UNITED STATES PATENT AND TRADEMARK OFFICE

APPLICATION NO.	FILING DATE	FIRST NAMED INVENTOR	ATTORNEY DOCKET NO.	CONFIRMATION NO.
10/706,320	11/12/2003	Craig S. Gittleman	GP-303297	6448

Office Action Summary

DETAILED ACTION

FIG. 5

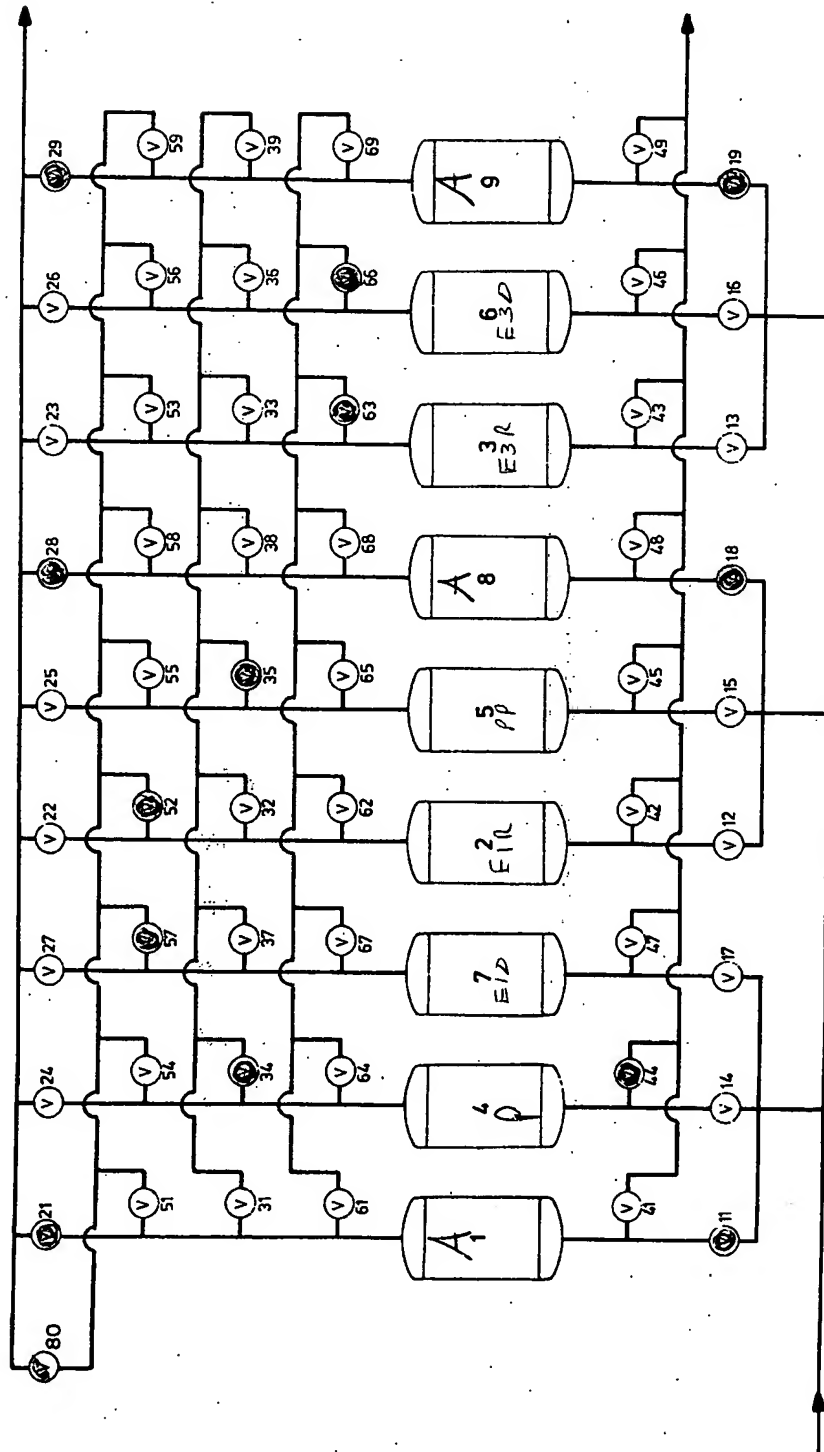
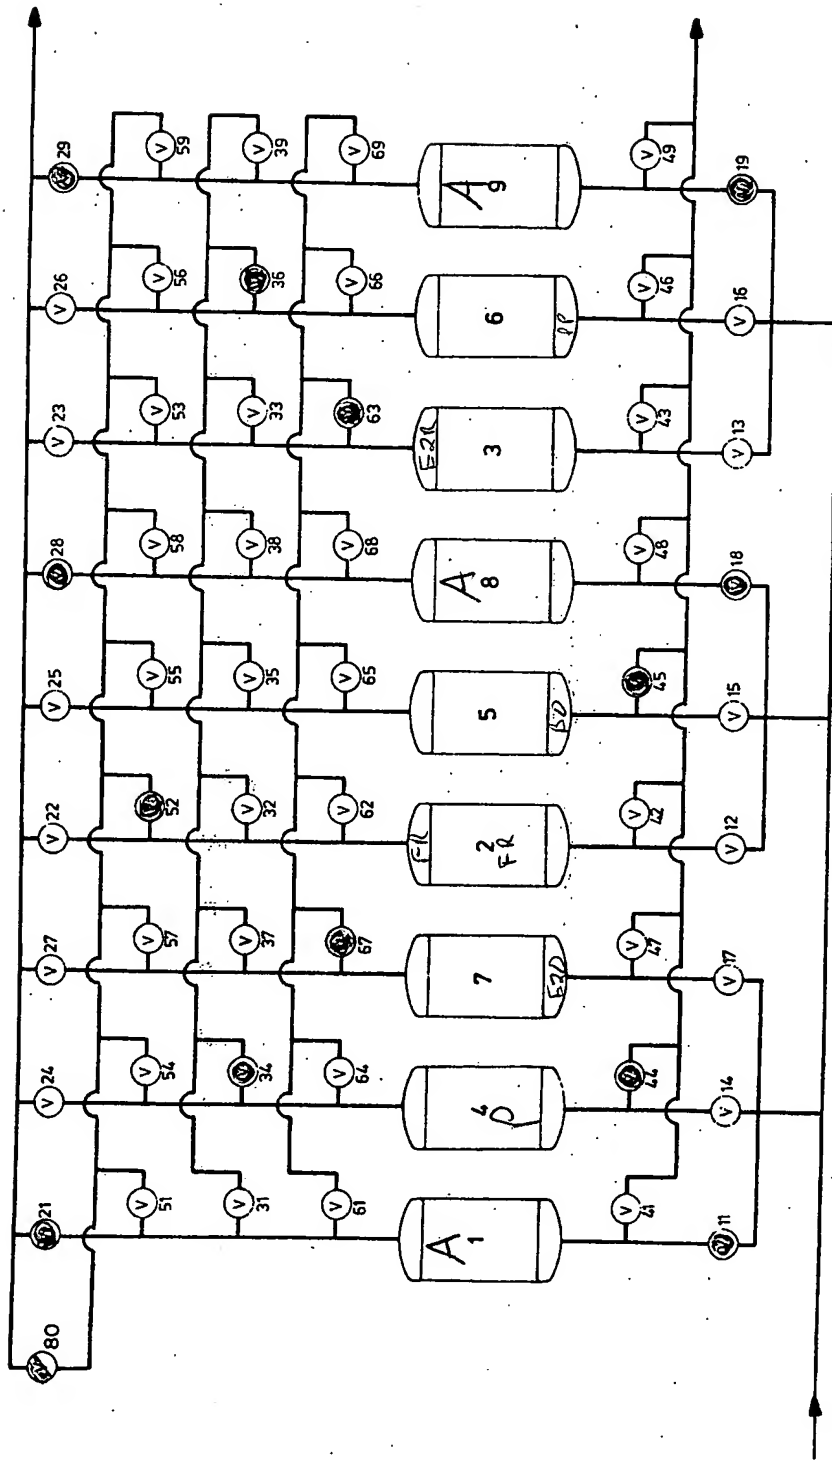
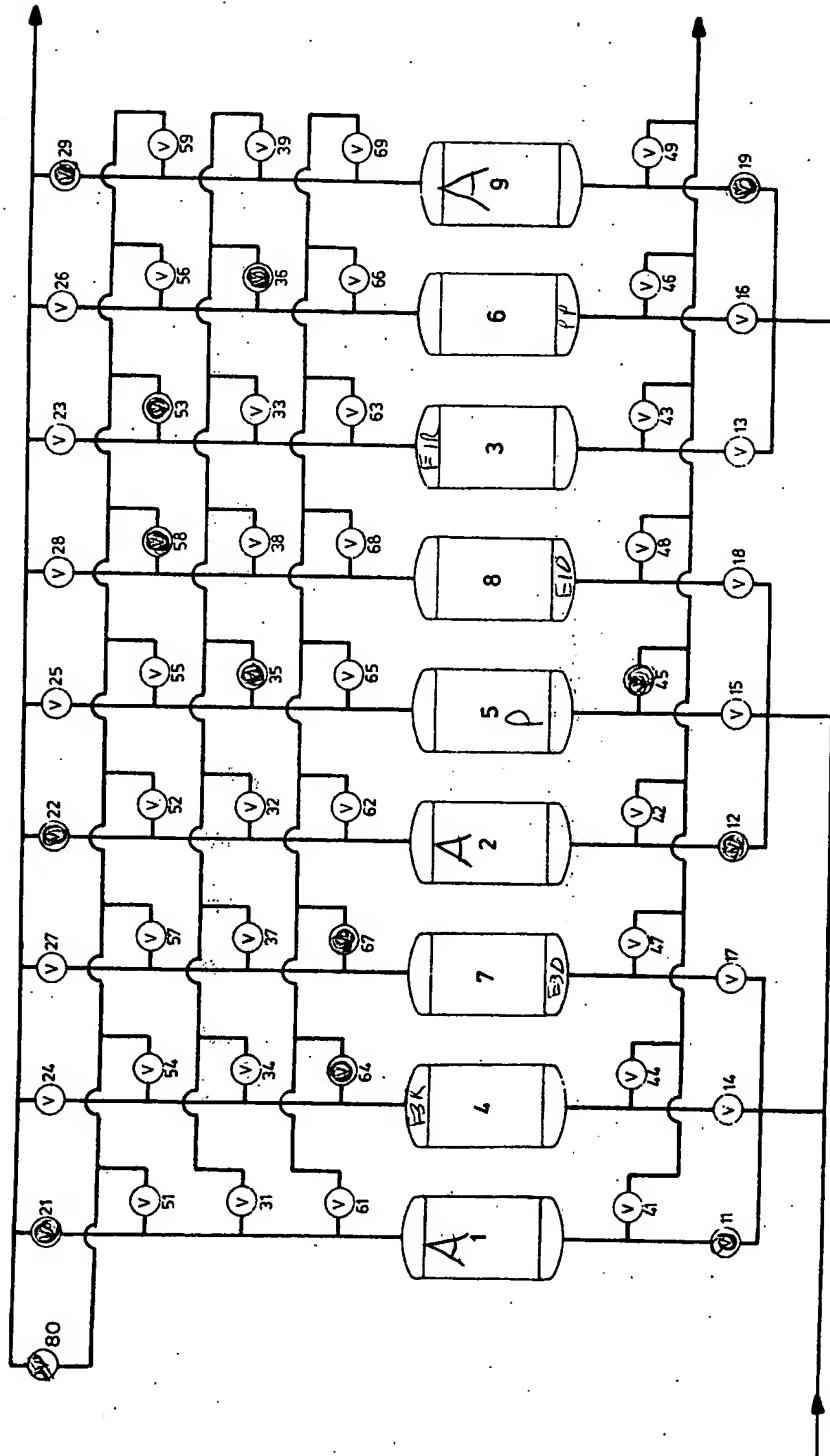
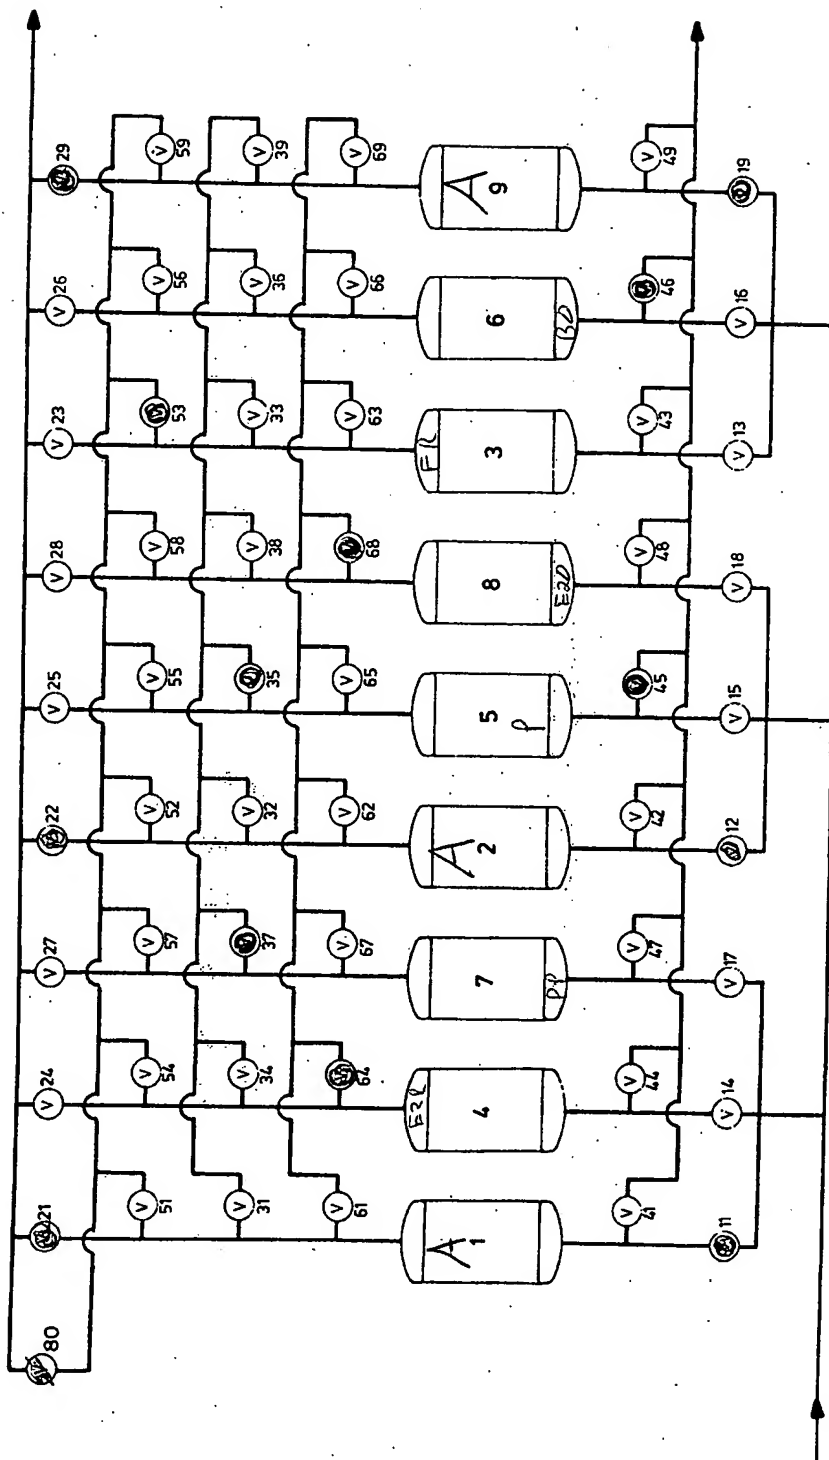
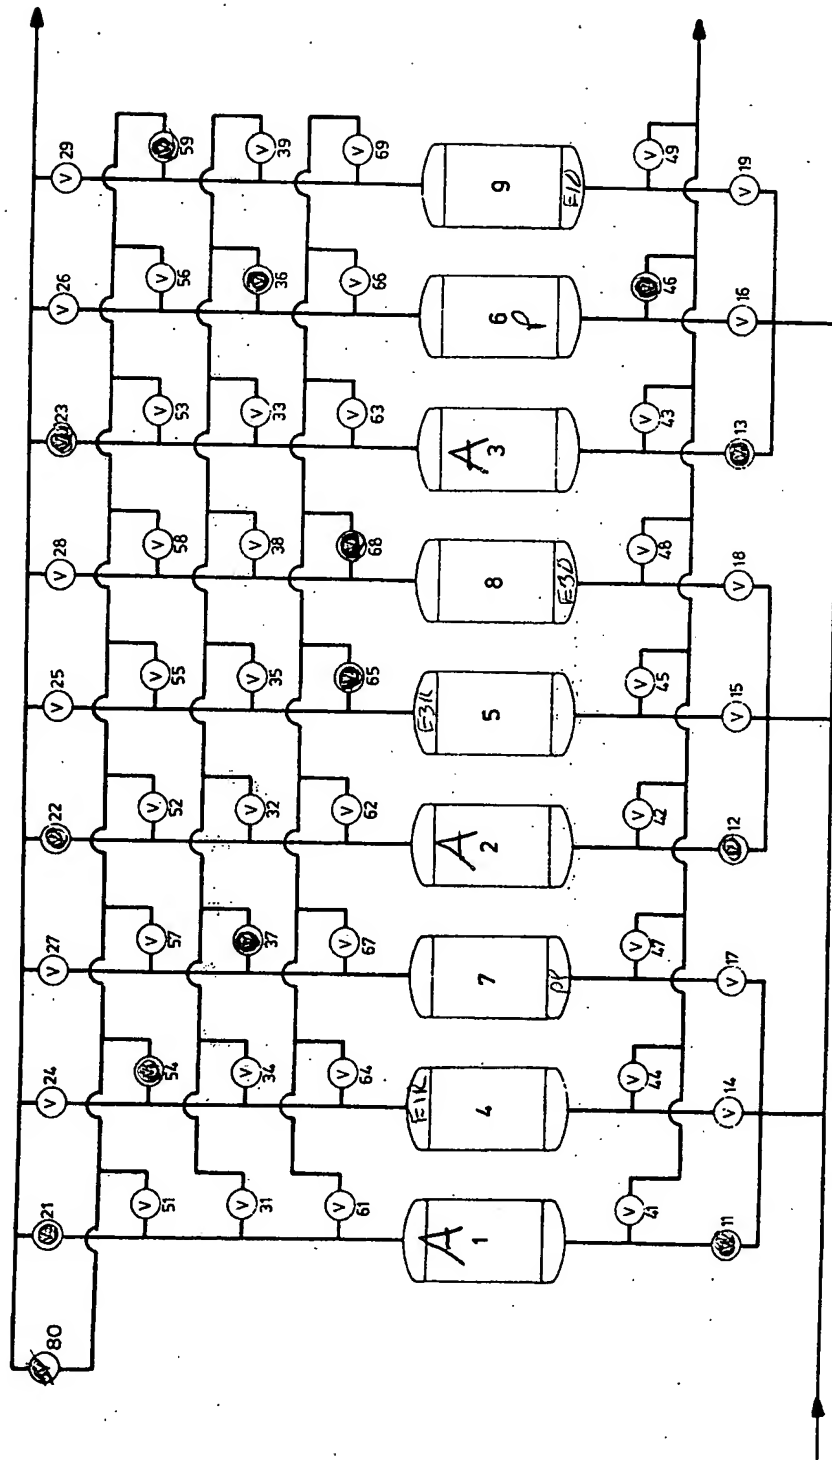
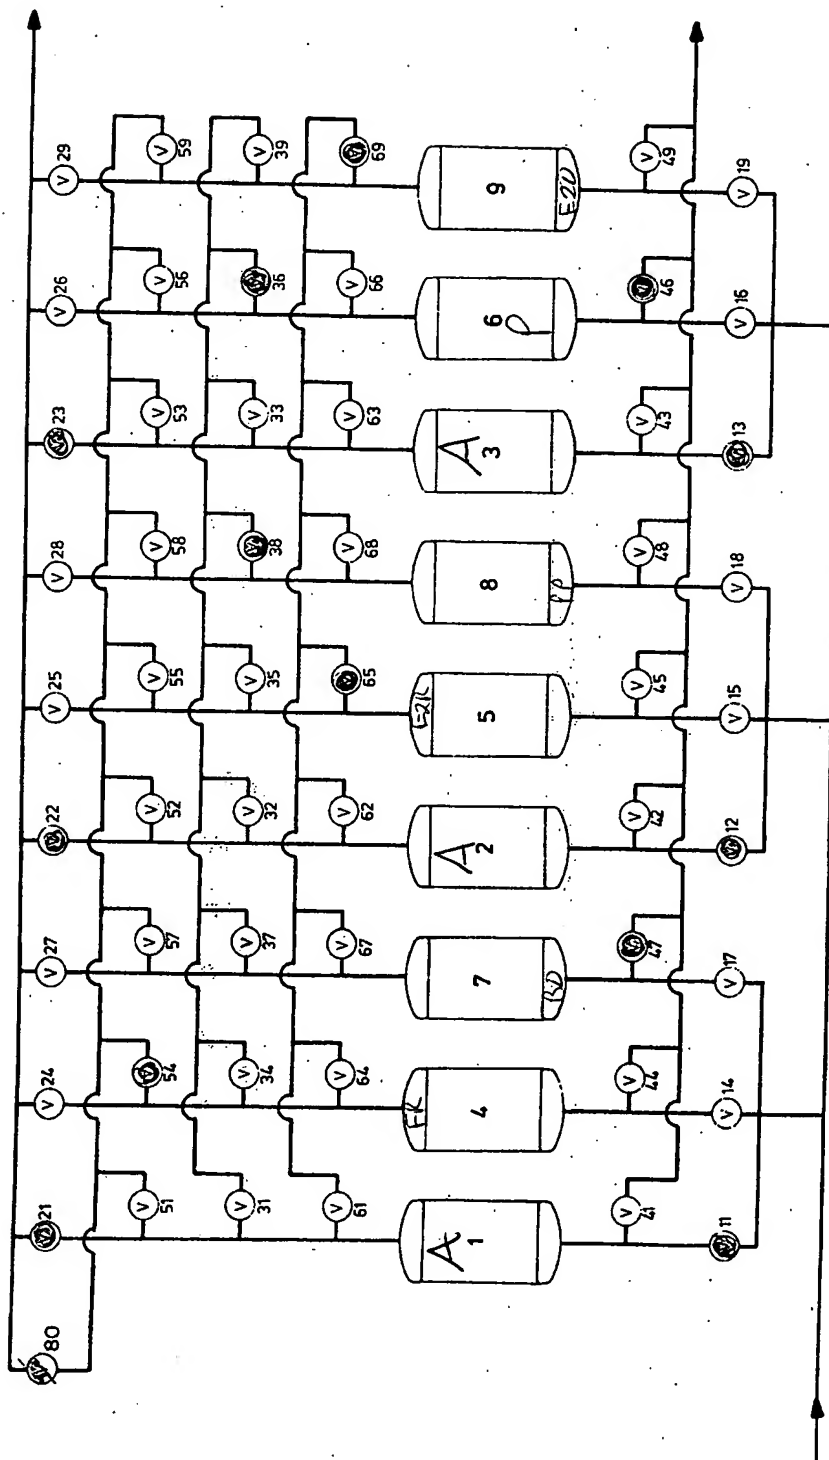
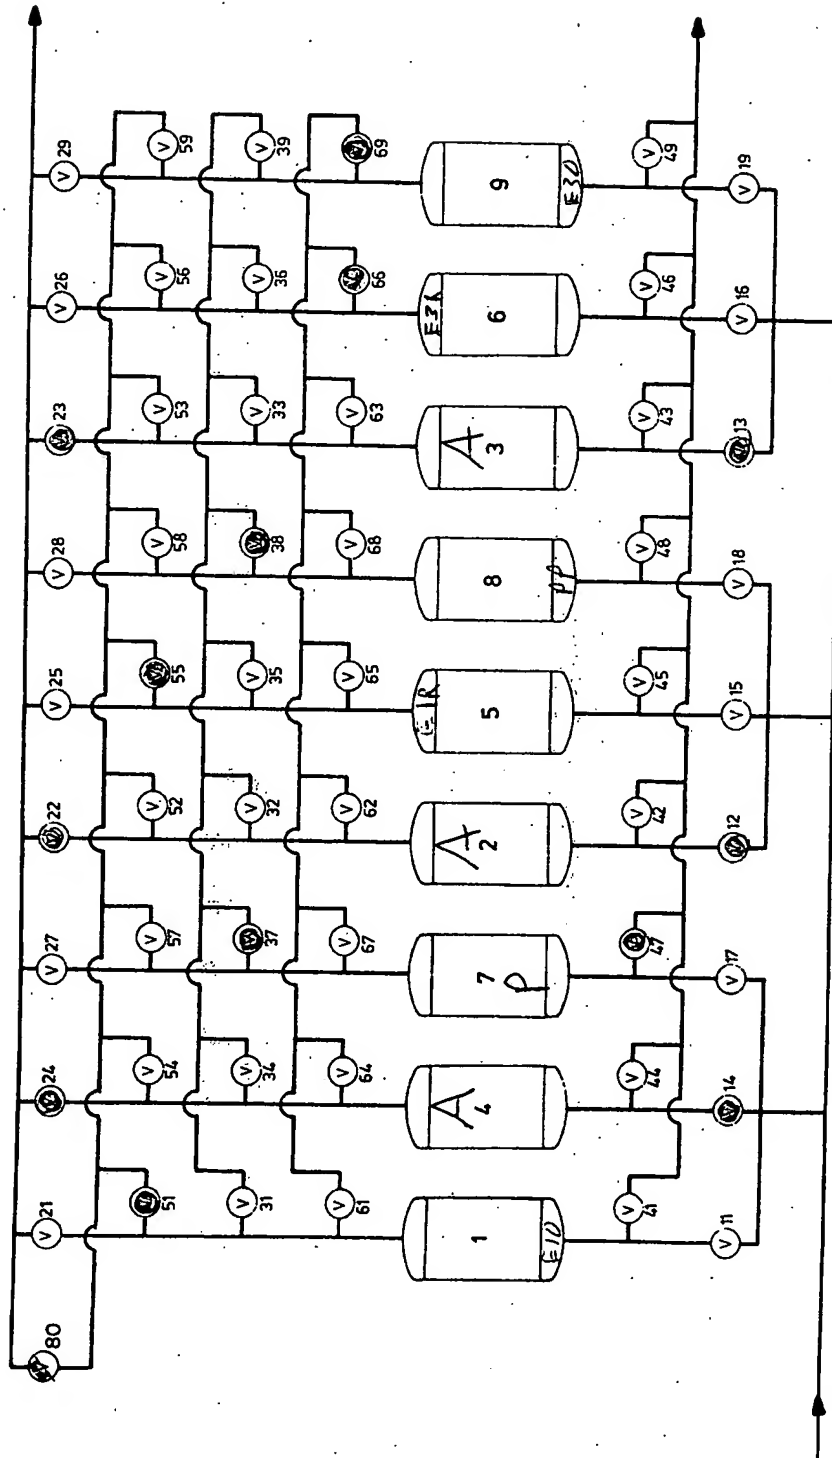
20. Applicant's arguments filed February 2, 2006 have been fully considered but they are not persuasive. Applicant argues that the blow down step in Fuderer does not take place directly following the equalization down stage, however in the embodiment of figures 5-7 for example,

the PP stage anticipates the second equalization down stage as claimed because the vessel product end is coupled to the product end of an adjacent vessel at a purge pressure to lower the pressure. Also, claim 1 as amended renders claims 6 and 7 indefinite because additional steps are inserted in between the down stage and blow-down stage. With respect to claim 52, the system is inherently capable of performing all of the steps regardless of the disclosed operation because it contains all of the structural components needed to do so.

21. Applicant also argues that Fuderer does not specify how the vessels are interconnected for the down stages, however the process flow diagram, time diagram, and valve operation chart of figures 5-7 for example show that the product ends are coupled. For applicant's convenience, the examiner has attached copies of figure 5 annotated for the first eight time cycles, showing open valves and vessel conditions. Applicant further argues the Fuderer fails to disclose vessel coupling in the PP stage, however note in the first time cycle for figure 5, for example, where vessel 5 in the PP stage is coupled to the product end of vessel 4 which is in a purge stage, via valves 34 and 35.

23. Applicant also argues that Fuderer fails to disclose a purge stage including feeding reduced-pressure product gas into the product end of the vessel, however this takes place as co-current product gas emanating from a vessel in a PP stage is directed to a vessel in a purge stage. With respect to claim 7, applicant argues that Fuderer fails to disclose fourth equilibrium down and up stages, however this embodiment is disclosed in figures 11-13, col. 12, line 66 to col. 13, line 26.
